LOI: VTX

Bill Cooper
Fermilab

Places where VTX is Mentioned

Figures and paragraph numbering
 are taken from v0.94.

Figure 1.6: The density of electron and positron tracks / cm² / BX in Layer #1 of the forward tracker, as a function of the radius of the hit.

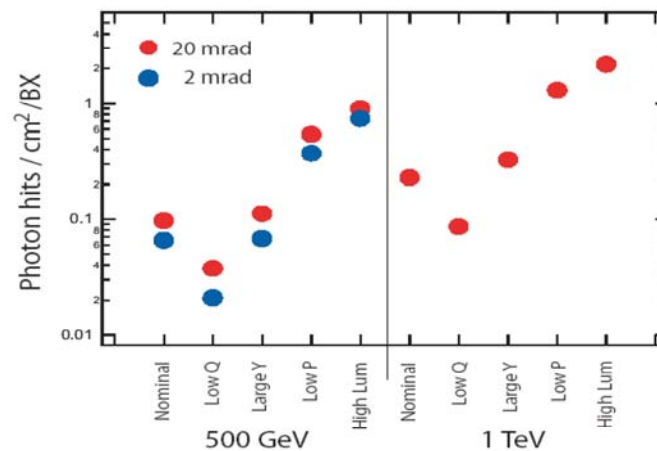
Machine parameters
 Spatial distribution and magnitudes of backgrounds
 Pattern recognition studies
 Hit densities in forward VTX disks
 EMI related to beam RF
 Figure 1.6 (at right) appears to
 correspond to the text describing
 Figure 1.3.
 Otherwise, looks fine

Figure 1.4: VXD Hits/mm²/train for Barrel Layer 1 for the various ILC beam parameter sets.

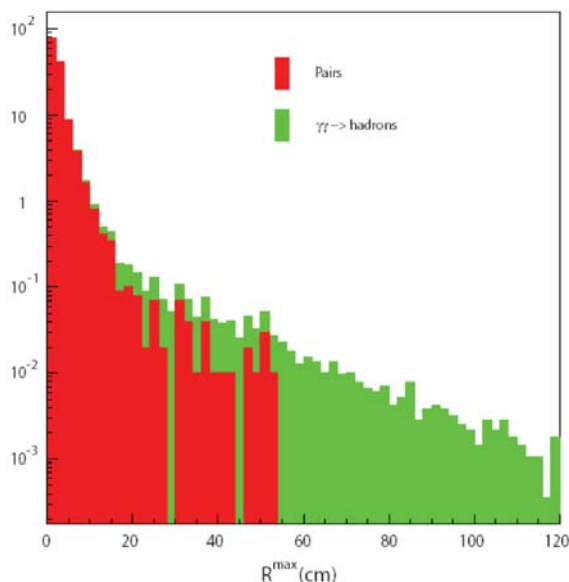
Main text descriptions of Figures 1.4 and 1.5 seem to be interchanged with respect to the figures themselves.

Figure 2.2: R-z view of the vertex detector and its support structure.

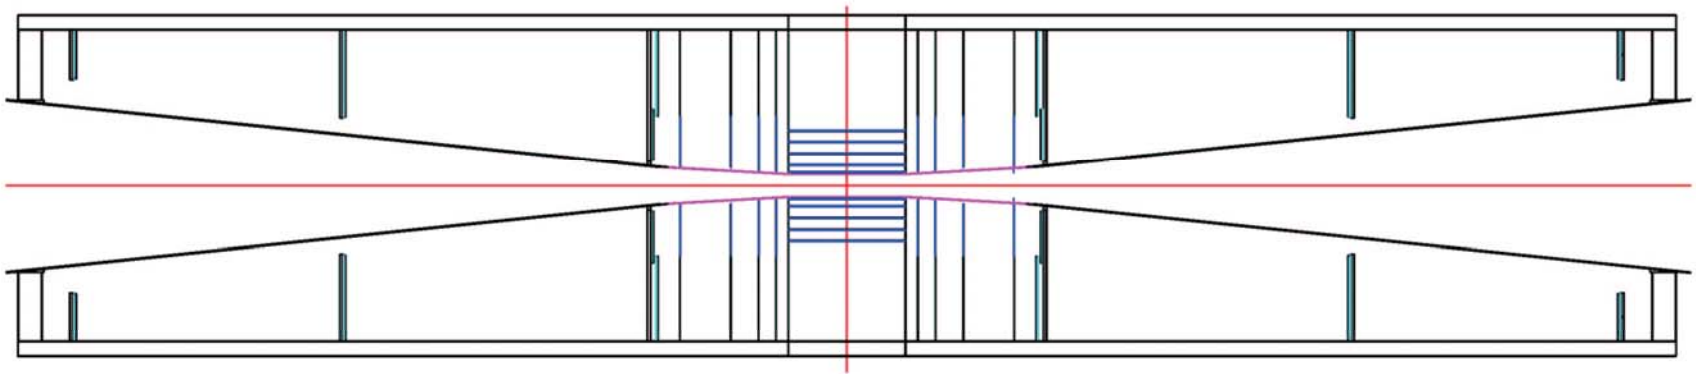
Paragraph 3, sentence 3: Change “occurs” to “occur”.

Figure 2.3: Barrel end view of the vertex detector (left) and layer arrangement of the silicon sensors only (right).

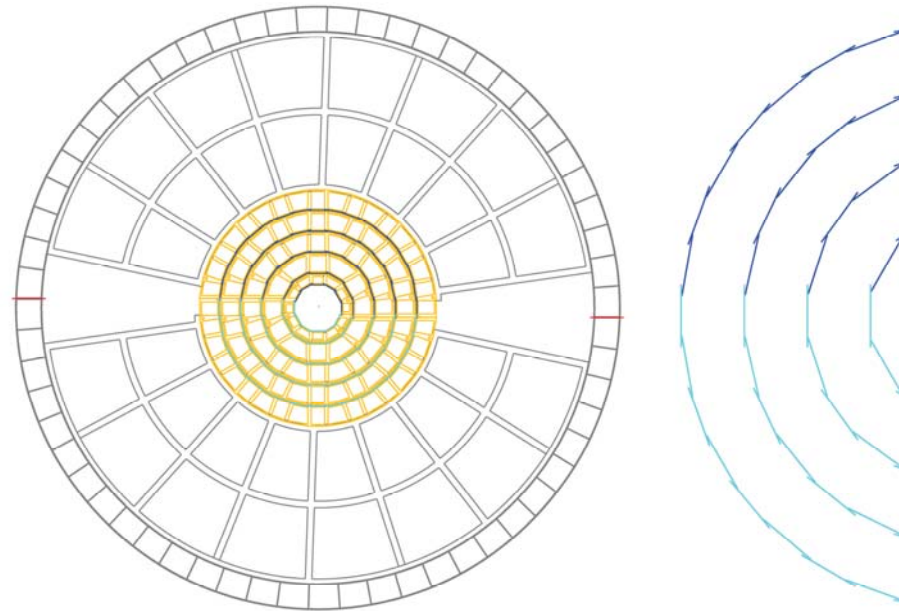
Looks fine, except for Fig. 2.3

Figure 2.3 is too wide to fit the page.

Figure 2.10: Material budget of the tracking system.

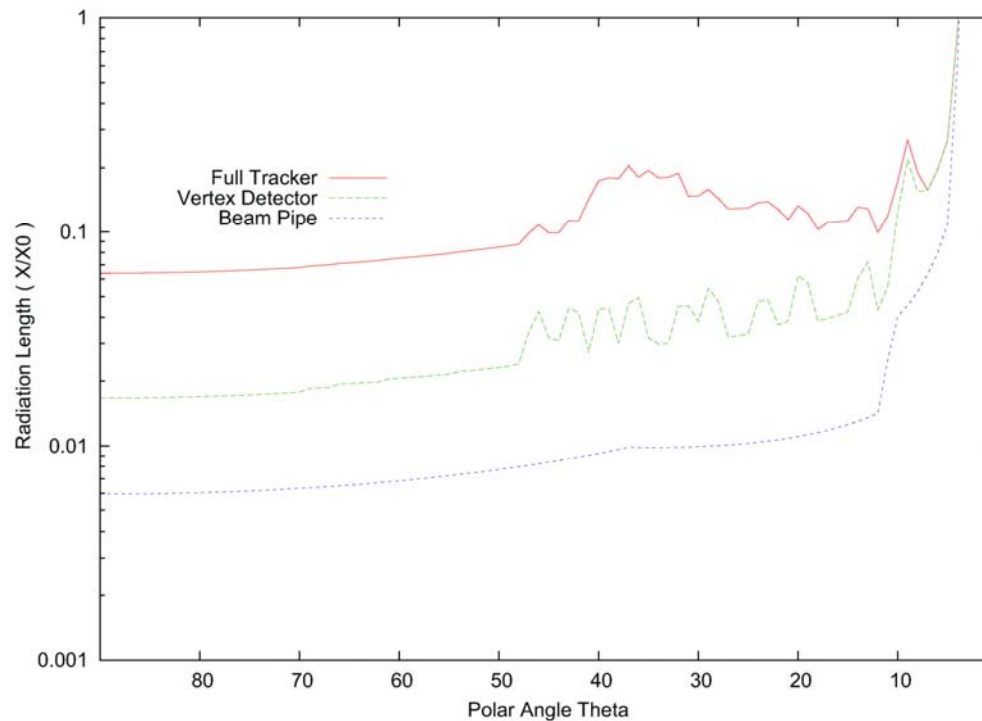
There is a statement “The number of radiation lengths represented by vertex detector structures, averaged over ϕ in most cases, is given in Fig. 2.10”.

Should that say Fig. 2.5?
